TO: Mercedes-Benz Dealer Principals, General Managers, Sales Managers, Service Managers, Parts Managers	FROM: Anthony Washington, Senior Manager, Regulations and Certifications
Re: Launch Recall Campaign Notification Model Sprinter 447 Model Years 2021-2022 Replace Fuel Delivery Module	DATE: December, 2023

Campaign No. :	Campaign Desc. :	Replace Fuel Delivery Module
2023100006	VS2KRAPUMP	
<p>This is to notify you of a Recall Campaign Launch to replace the fuel delivery module on approximately 8,181 MY 2021-2022 Mercedes-Benz Metris vans. The recall campaign will be visible on the www.safercar.gov website and may generate questions from customers. All affected VINs will be flagged "OPEN" in VMI and cannot be sold until the recall has been remedied.</p>		
Background		
Issue	<p>Mercedes-Benz AG, the manufacturer of Metris vans, has determined that on certain Metris (447 platform) vehicles the fuel pump impeller might not meet specifications in regards to material characteristics. As a consequence, the impeller might deform and come into contact with the fuel pump housing, leading to a mechanical resistance. In some instances, this could lead to a shutdown of the fuel pump. As a resul

S47.20-A027-03

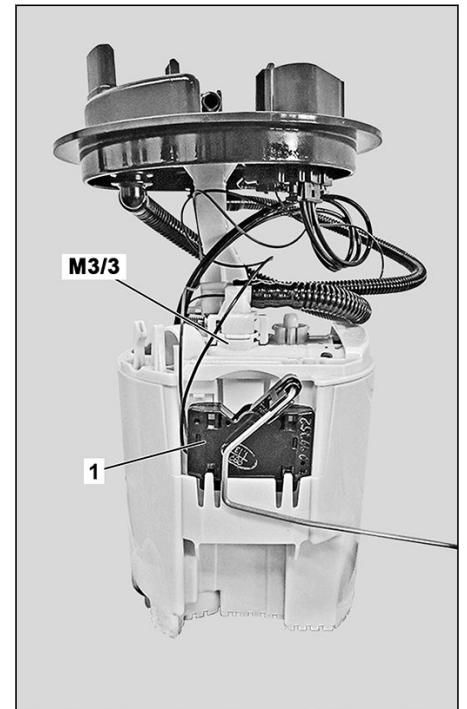
Remove		
4 	Remove fuel pump with fuel delivery module (M3/3).	<p> Model 447 except code ZL3 (National version for Latin America)</p> <p>Contrary to the statement in the reference document on removal of the fuel tank, the fuel hose (2) does not need to be removed.</p> <p>The filler neck (3) is only detached from the body and remains on the fuel tank.</p> <p> The removed fuel pump with fuel delivery module (M3/3) is not reused.</p> <p>Dispose of removed component parts that are not reused properly. Observe the applicable legal requirements and specifications of the relevant country.</p>	AR47.20-S-7000E
	Modify		
5 	Transfer fuel tank fill level sensor (1) of removed fuel pump with fuel delivery module (M3/3) to new fuel pump with fuel delivery module (M3/3).	Only if new fuel pump with fuel delivery module (M3/3) was delivered without fuel tank fill level sensor (1).	AR47.50-S-0111E
	Install

6 	Install new fuel pump with fuel delivery module (M3/3).		AR47.20-S-7000E
	Finishing activity		
7	Switch off air extraction system for benzene fumes and remove from working area.
